Heavy Vehicle Local Road Report Parramatta

Project Name:	Sydney Metro West		
Client Name:	Sydney Metro		
Project Address:	DELTA will be working at the following sites: 1. Parramatta 2. Clyde 3. Westmead		
Project Description/Scope:	DELTA Pty Ltd (DELTA) is responsible for the demolition of existing structures including removal of all hazardous materials and utility works of the Sydney Metro West Project at Clyde, Parramatta and Westmead		
Prepared By:	Name: S Lewis	Signature: 	Date: 7 th October 2021
Reviewed By:	Name: A Lumsden	Signature: 	Date: 7 th October 2021
Authorised By (Project Director):	Name: B Shum	Signature: 	Date: 7 th October 2021

Project	SSI 10038 – Sydney Metro West
Document	10038-PA-47 – Heavy Vehicle Local Road Report Parramatta – Rev 2, dated sept 22 2021
Date received from Sydney Metro	Sept 22 2021
Date comments sent to Sydney Metro	Sept 29 2021

Figure 8: Land use - Parramatta (source: Chapter 14 Property and Land Use EIS)

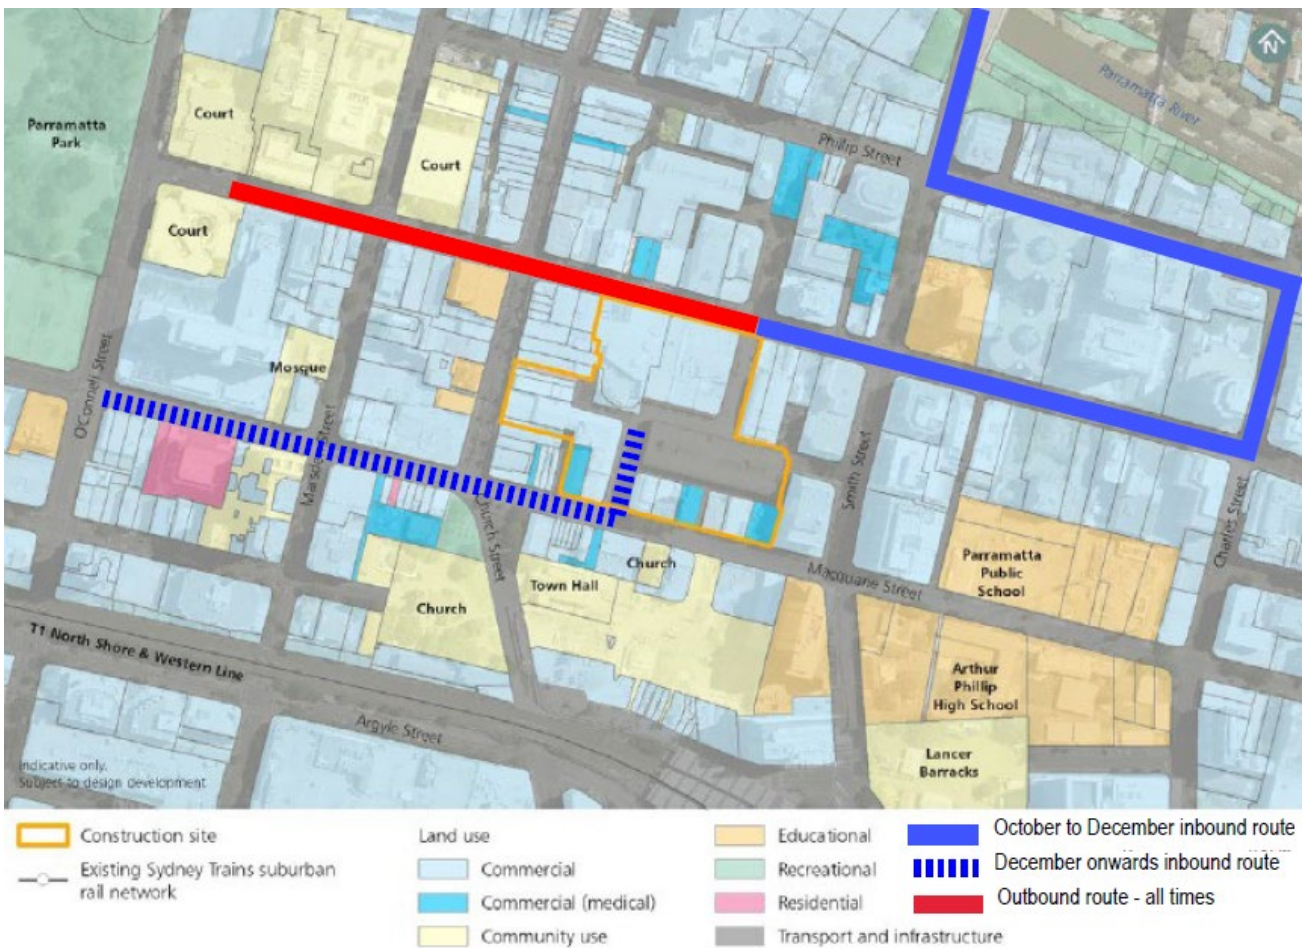
Pedestrian access will be restricted to the southern side of Macquarie Street, other than for access to the retail premises between Church Street and United Lane on the northern side of Macquarie Street	Minor Non-Compliance	N
				24	10/09/2021	SMD	BGORDON	SMWSDDS-DLT-PTA-TF-REP-000059	Figure 8	General Specification	This figure shows the surrounding social infrastructure, but there is no discussion/analysis on how the proposed non EIS heavy vehicles routes impact them or what the mitigations may be if they do. This does not address MCoA87(B). Update HVLR accordingly.	Minor Non-Compliance	N
								SMWSDDS-DLT-PTA-TF-REP-000059	Figure 8	General Specification	Document amended	Minor Non-Compliance	N

24.01.01	22/09/2021	SMD	BGORDON				Yes, the map shows existing conditions, the route proposed goes past that (and other) existing conditions. For example one of the existing conditions is Western Sydney University. Does the route proposed have an impact on students and the University? If so, what are the mitigation? That is what is required by DPIE.	Minor Non-Compliance	N
											There is no impact to Western Sydney University as it is located on Smith Street between Phillip Street and George Street which is not part of the proposed heavy vehicle route	Minor Non-Compliance	N
				37	17/09/2021	HBI	SGOWDA	SMWSDDS-DLT-PTA-TF-REP-000059	Heavy Vehicle Local Road Report - Table 1	D87	Table 1: Ministerial Conditions of Approval requirements for HVLRMcoA D83 relevant to HV is not addressed in this Table and document. Review/update accordingly.	Actual Non-Compliance	N
								SMWSDDS-DLT-PTA-TF-REP-000059	Heavy Vehicle Local Road Report - Table 1	D87	Not applicable - refer to Schedule 20 from Sydney Metro	Actual Non-Compliance	N

24.01	20/09/2021	DLT	DKADYAN	SMWSDDS-DLT-PTA-TF-REP-000059	Figure 8	General Specification	This section is describing Existing Conditions. As noted in the report there is no other available routes- refer to Section 8	Minor Non-Compliance	N
								SMWSDDS-DLT-PTA-TF-REP-000059	Figure 8	General Specification	Figure updated	Minor Non-Compliance	N

Figure 17: Proposed Christmas 2021 traffic changes

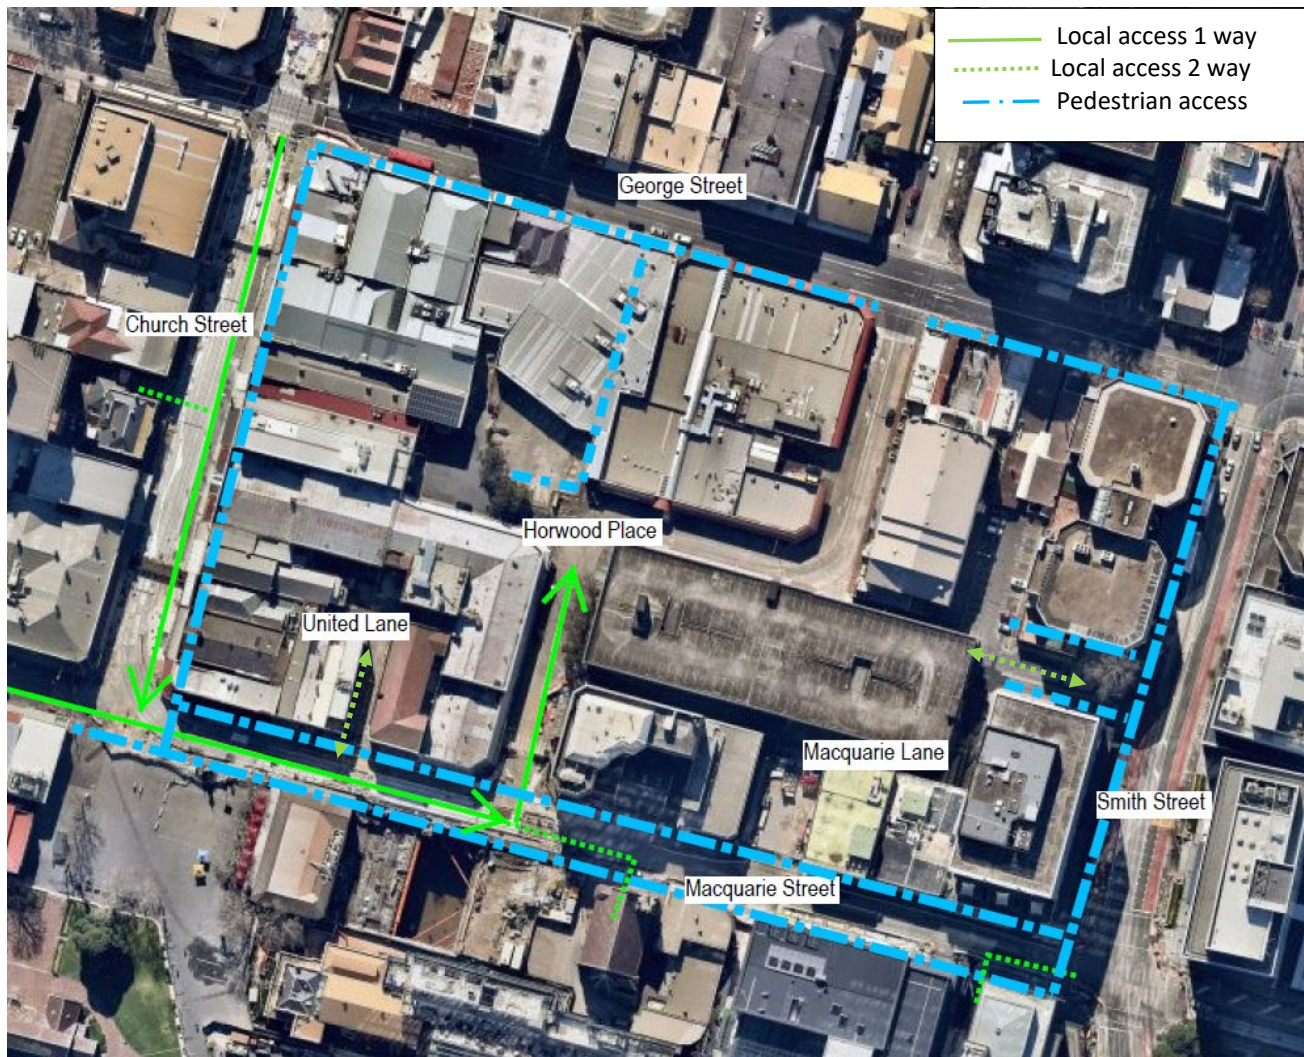
SMWSDDS-DLT-PTA-TF-REP-000059	Figure 17	2.11.1 (f) of the General Specification	This is the route provided by Sydney Metro as part of the Demolition contract award. The initial route (Sept to Dec) is a compromise route to allow all works as noted in section 8.2 and as noted in section 8.3. Pedestrians will be maintained on the southern footpath of Macquarie Street only removing the interface between vehicles and pedestrians at the intersection of Horwood Place and Macquarie Street	Minor Non-Compliance	N

SMWSDDS-DLT-PTA-TF-REP-000059	Figure 17: Post Christmas proposed inbound route		Noted, ongoing coordination meetings are held between Sydney Metro, TfNSW's Parramatta Light Rail project tem, Parramatta Connect, CJP and DELTA on access arrangements	Observation	N
				51	24/09/2021	PAR	MJOLLON	SMWSDDS-DLT-PTA-TF-REP-000059	General Comment		It has been proposed that the applicant will provide a dilapidation report for affected roads. Once the project is completed, they will either rectify any damage or pay for its repair. This is fine, however, there is no information on the regime of regular road inspections and who will be doing maintenance during the project.	Observation	N
								SMWSDDS-DLT-PTA-TF-REP-000059	General Comment		There is no requirement for maintenance of roads	Observation	N
				52	24/09/2021	PAR	MJOLLON	SMWSDDS-DLT-PTA-TF-REP-000059	General Comment		There is no information on any compensation to Council for long term damage to road pavements such as an increase in pavement wear as result of increased number of heavy vehicles on roads. During the other project that affected some roads in Epping (Sydney Metro North project), we received compensation for increased number of buses on our roads during the closure of railway line. The compensation was calculated in accordance with TfNSW publication: Roads and Maritime Services Report, Analysis of Marginal Cost of Road Wear - Based on pavement life cycle costing', 21st April 2011. Could the same methodology be used in this case?	Observation	N

12.01	20/09/2021	DLT	DKADYAN	SMWSDDS-DLT-PTA-TF-REP-000059	Figure 17	2.11.1 (f) of the General Specification	This is the route provided by Sydney Metro as part of the Demolition contract award. The initial route (Sept to Dec) is a compromise route to allow all works as noted in section 8.2 and as noted in section 8.3	Minor Non-Compliance	N
								SMWSDDS-DLT-PTA-TF-REP-000059	Figure 17	2.11.1 (f) of the General Specification	This is the route provided by Sydney Metro as part of the Demolition contract award. The initial route (Sept to Dec) is a compromise route to allow all works as noted in section 8.2 and as noted in section 8.3. Pedestrians will be maintained on the southern footpath of Macquarie Street only removing the interface between vehicles and pedestrians at the intersection of Horwood Place and Macquarie Street	Minor Non-Compliance	N
